Access Compliance Report

Public Rights-of-Way

(Curb Ramps)

Intersection ID: 21548	Main Street: OLD_PROVIDENCE_RD	Cross Street: PROVIDENCE_RD	Location: S
ADA ID: 989A89C3E92F	Ramp Type: IslandPerp	Initial Pass/Fail: Fail	Overall Compliance: No
Severity Score: 13.75			
Codes/Mitigation Info/Possible Solution		Field Measurements/Component Compliance

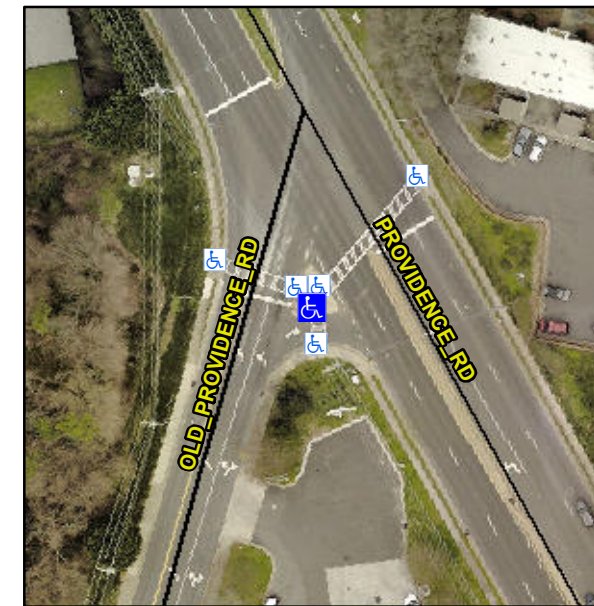
R304.2.2, R304.5.3

Compliance	Description	Data	Compliance	Description	Data
N/A	Ramp Length (in)	48.0	No	Ramp Slope (%)	8.6
Yes	Ramp Width (in)	48.0	No	Ramp XSlope (%)	3.3
N/A	Flare Type LT	N/A	N/A	Flare Type RT	N/A
N/A	Flare Slope LT (%)	N/A	N/A	Flare Slope RT (%)	N/A
N/A	Flare Traversable LT?	N/A	N/A	Flare Traversable RT?	N/A
N/A	Landing Length (in)	N/A	N/A	DWS Provided?	N/A
N/A	Landing Width (in)	N/A	N/A	DWS Contrast?	N/A
N/A	Landing Slope (%)	N/A	N/A	DWS Length (in)	N/A
N/A	Landing X Slope (%)	N/A	N/A	DWS Full Width?	N/A
N/A	Landing Curb? (Y/N)	N/A	N/A	DWS Offset (in)	N/A
N/A	Shared Landing?	N/A			
N/A	Gutter Ponding?	N/A	N/A	Gutter Slope (%)	N/A
N/A	Gutter Lip Ht (in)	N/A	N/A	Gutter X Slope (%)	N/A
N/A	Painted X Walk1?	Yes	N/A	Painted X Walk2?	N/A
	X Walk 1 Direction	To S		X Walk 2 Direction	N/A
N/A	X Walk 1 Width (in)	70.0	N/A	X Walk 2 Width (in)	N/A
	X Walk 1 Slope (%)	3.5		X Walk 2 Slope (%)	N/A
	X Walk 1 X Slope (%)	0.6		X Walk 2 X Slope (%)	N/A

N/A	Ramp inside XWalk1?	Yes	N/A	Ramp inside XWalk2?	N/A
	Road Slope (%)	N/A	N/A	Clear Space?	N/A
	Road X Slope (%)	N/A	N/A	Clear Space to XWalk (in)	N/A
N/A	Any Obstructions?	N/A	N/A	Storm Grate/Utility Hazard?	N/A
	Obstruction Type			Storm Grate/Utility Type	
		N/A			N/A
		Yes		Surface Condition? (G/P)	Good

Remove & Replace Entire Ramp.
